4. ROW Vacation; KPB File 2026-006V

ITEM #4 - RIGHT OF WAY VACATION

KPB File No.	2026-006V
Planning Commission Meeting:	February 9, 2026
Applicant / Owner:	David and Christina Hall of Nikiski, Alaska
Surveyor:	Andrew Hamilton, McLane Consulting Inc.
General Location:	Intersection of Narrow Road and De Busk Drive, Nikiski Area
Legal Description:	NARROW ROAD, T 07N R 11W SEC 04 Seward Meridian KN 2025014 IMMANUEL SUB NO 2 LOT 11 THROUGH 14

STAFF REPORT

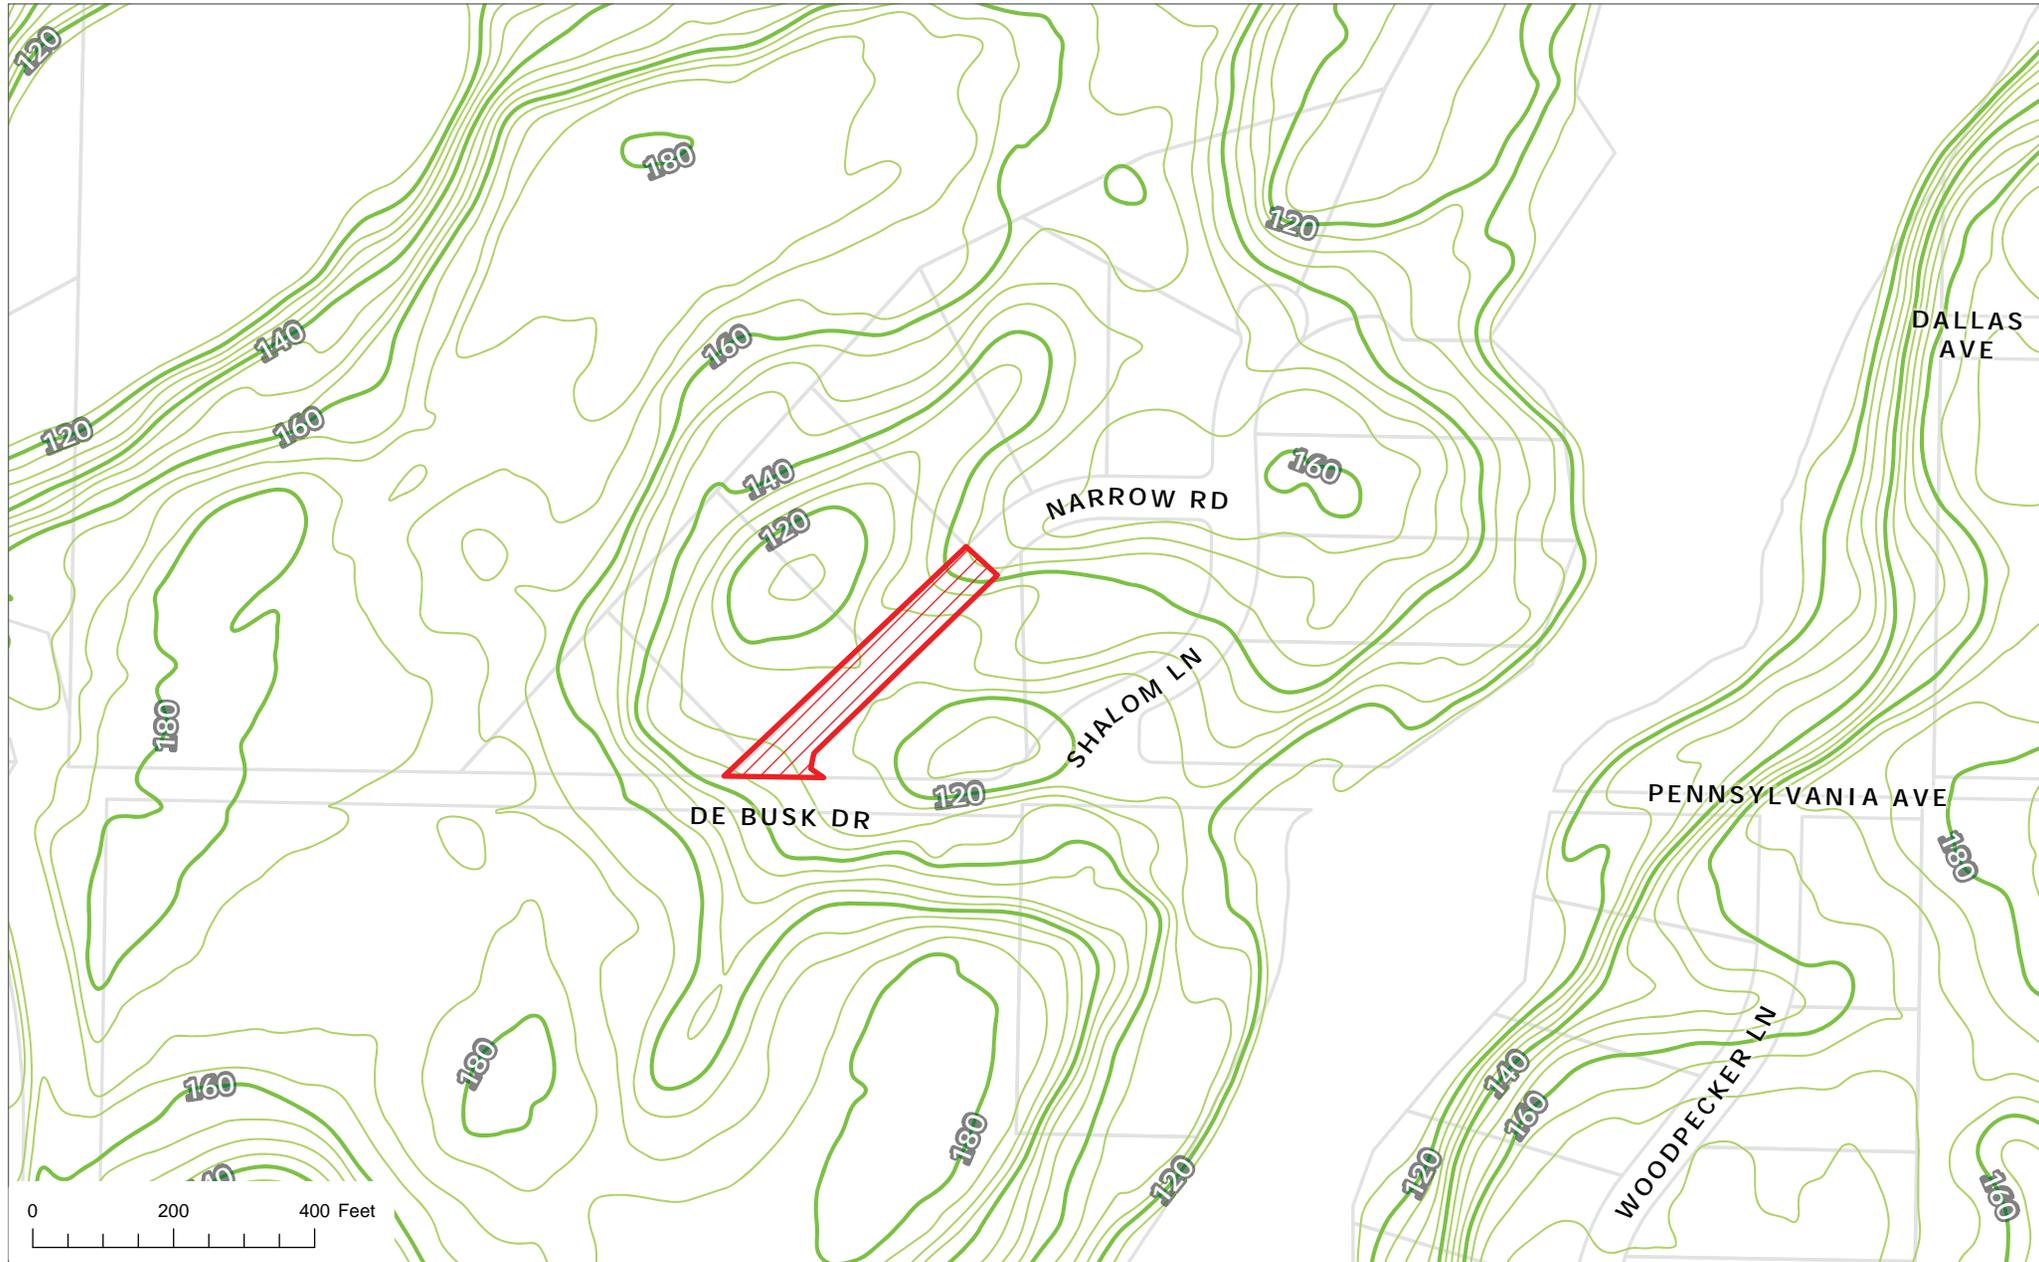
Adjust hatching to cover correct vacation area.

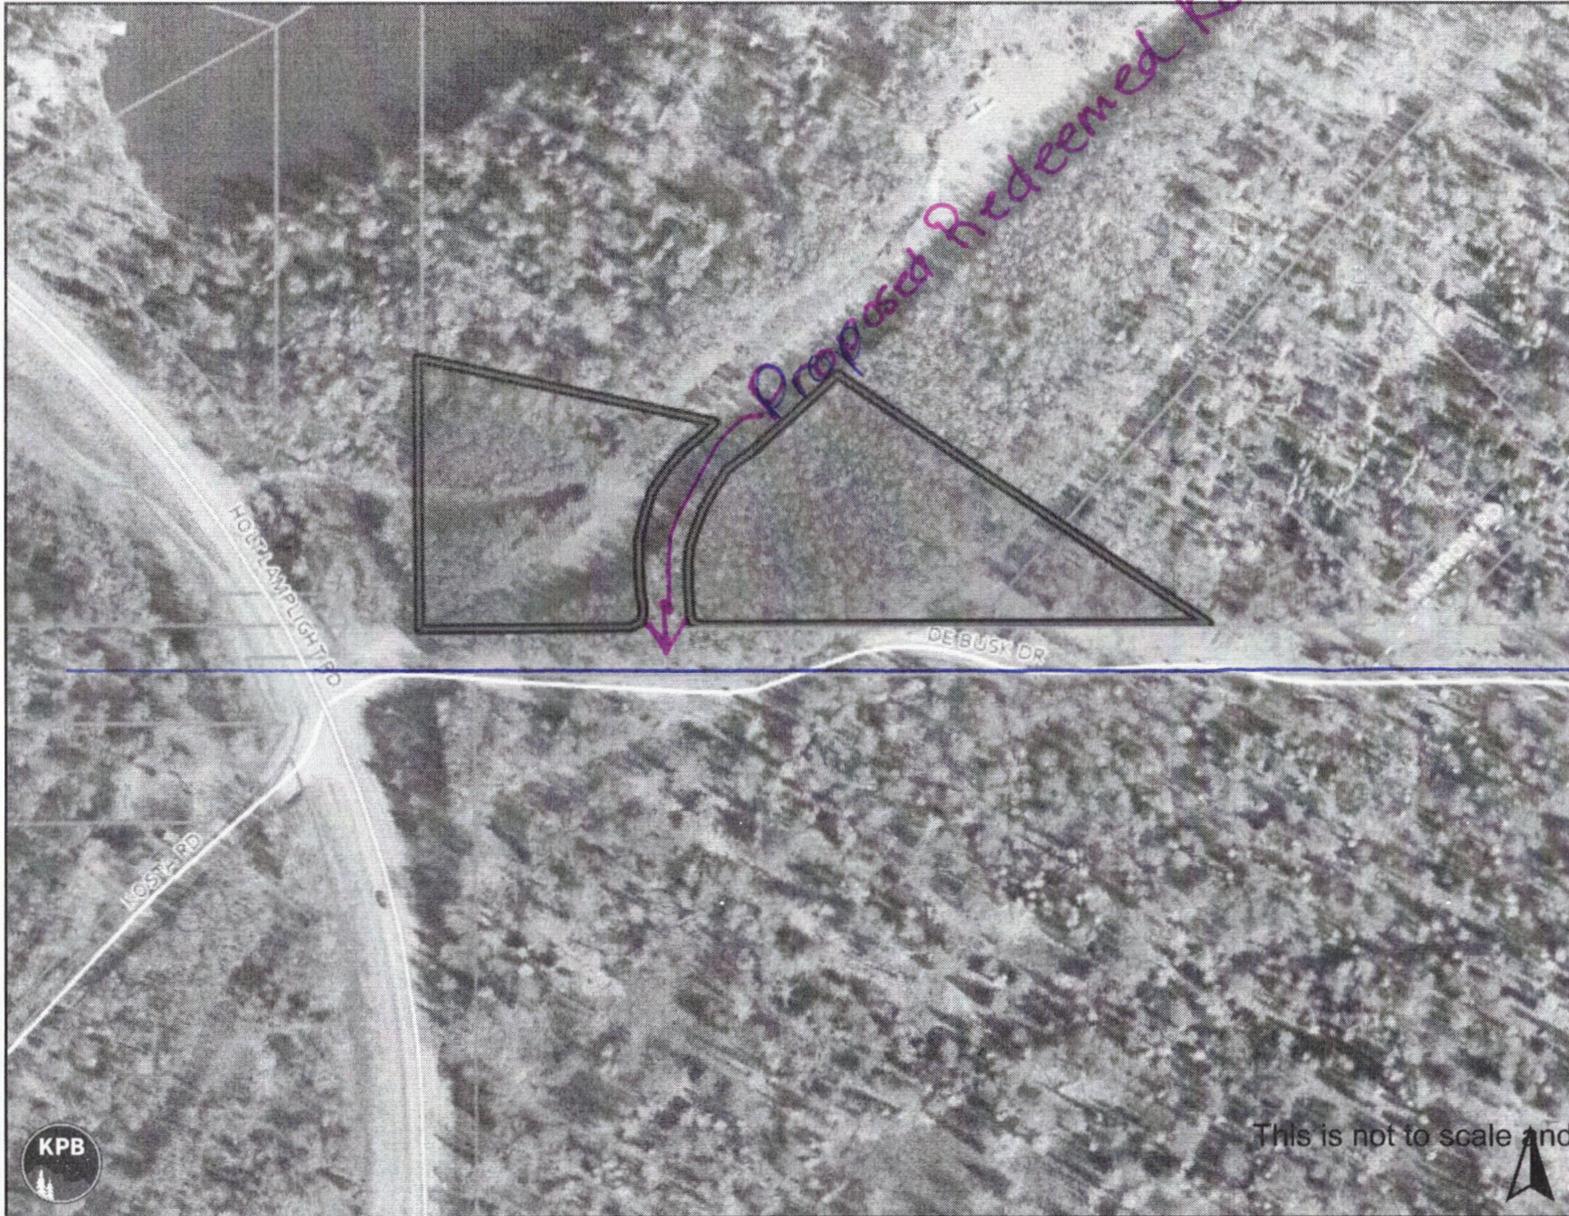
DeBusk Drive encroaches upon private property directly across from the subject property in 2 places. One is where the proposed Redeemed Road will intersect with DeBusk. The other is where the proposed Shalom Road will intersect with DeBusk.

Redeemed Road: The ingress and egress needs to be relocated such that it does not encroach on the private property across from it. Alternatively, the encroachment issue needs to be resolved between Chmielowiec and KPB platting.

SC 1 Immanuel Subdivision KPB GID proposed plat showing Redeemed Road proposed placement. The path of DeBusk can be seen as it crosses in and over the property line of the Chmielowiec property.

Redeemed Debusk interestion encroachment 2

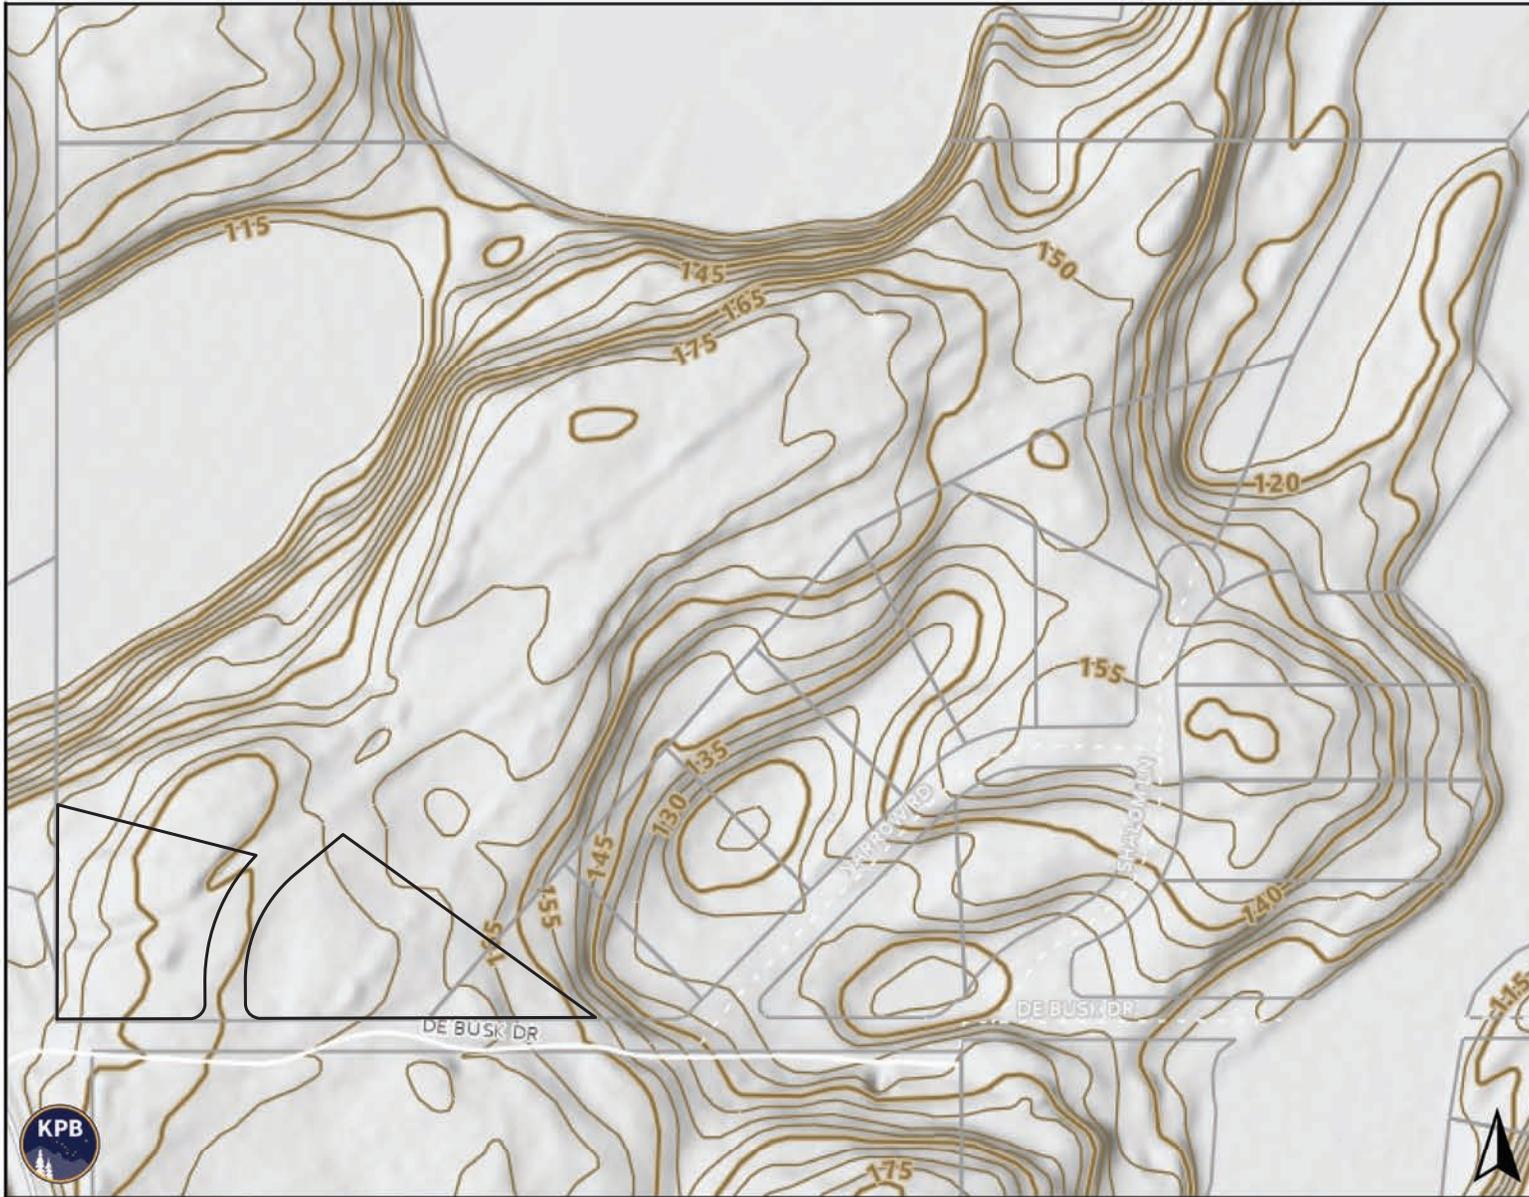
SC 3 Photo of DeBusk encroachment at proposed Redeemed intersection. Land to the left of the pink marks are private property.

SC 4 Photo of DeBusk encroachment at proposed Redeemed intersection. Land to the left of the pink marks are private property.

SC 5 Photo of DeBusk encroachment at proposed Shalom intersection. Land to the left of the pink marks and pink flagged stake are private property. The photo also shows the steep cliff Shalom would have to resolve. Shalom can be seen in the photo at the bottom of the hill. The plat proposes linking the current location of Shalom with DeBusk.

marked Final Plat Exhibit with Debusk

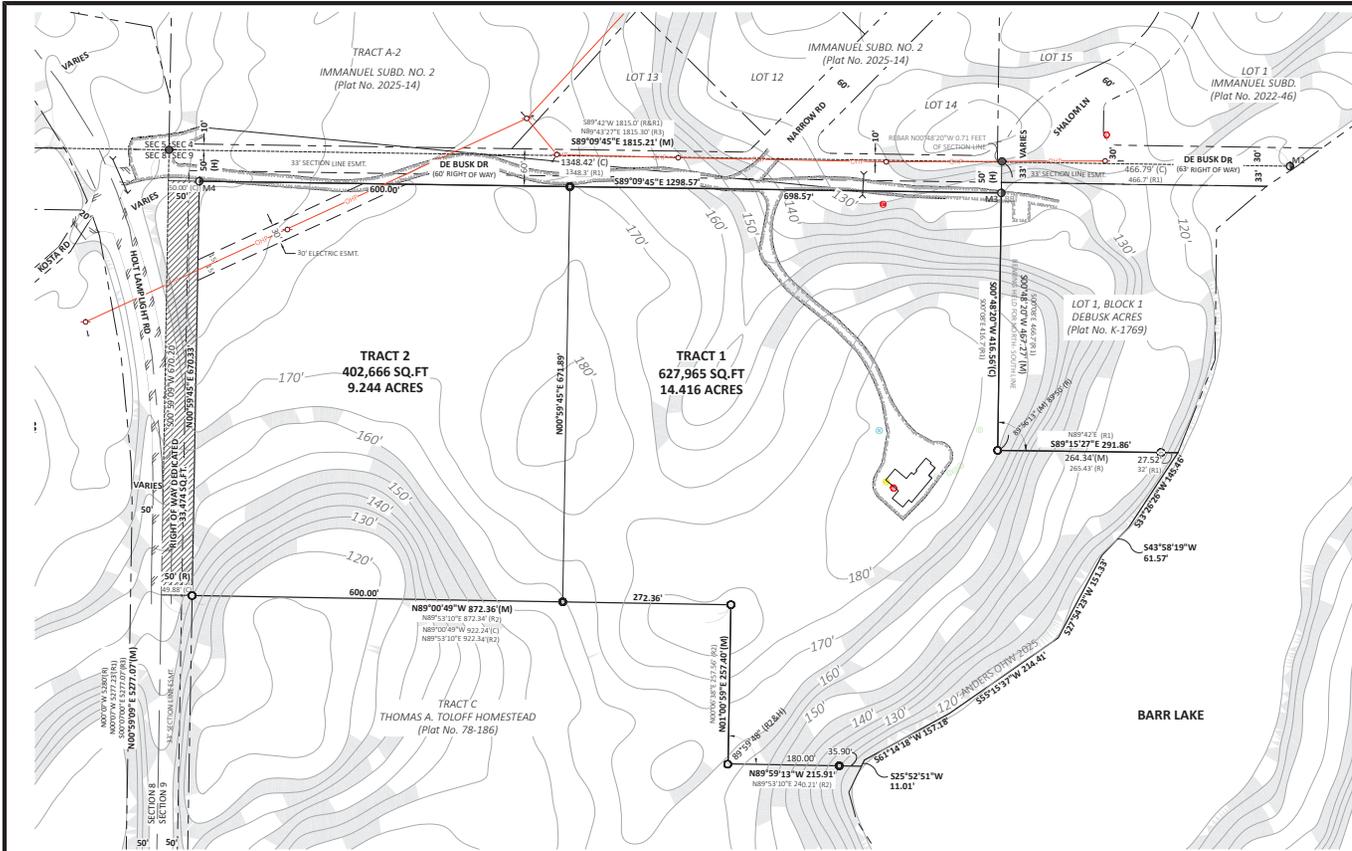
The encroachment on DeBusk was documented by Chmielowiec's surveyor. It is unclear and unknown why McLane does not show the path of DeBusk and the encroachment.

SC 7 Proposed plat of Big Bear Lookout. It is Chmielowiec's unapproved, pending plat that shows the encroachment of DeBusk onto the property that was derived from an original plat from 2023. The original plat and the current proposed plat show the path of DeBusk and its encroachment onto the property.
